February 17, 2017

**Re: SW Ring Road (SWRR) Implementation**

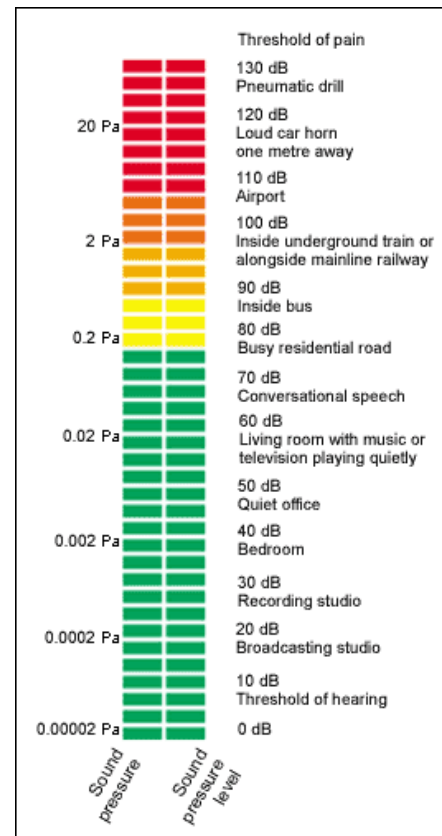
The following chart is included in order to categorize sound levels in a simple manner that is meaningful to everyone.

The Province uses a threshold of 65 Dba Leq (24hours) to determine the requirement of sound attenuation measures to ensure this threshold is not exceeded. 65 Dba would simulate conversational speech, which we note is quite audible even through closed windows, and can become disturbing if heard outside one’s house on a consistent basis. This is particularly true during nighttime (sleep) hours.

AT did share a draft sound study (completed by Patching) that modeled the sound effects given this threshold, but we feel the portion of the SWRR that will pass north of DR is in fact an urban setting within the City of Calgary, and that the City of Calgary sound attenuation requirements (60 dBA Leq or Peak hour requirements) should be applied to this sound study to determine whether incremental sound attenuation is required. We would like to see the sound study updated with the more stringent City of Calgary requirements and such that it becomes the baseline for all future sound monitoring and mitigation measures.
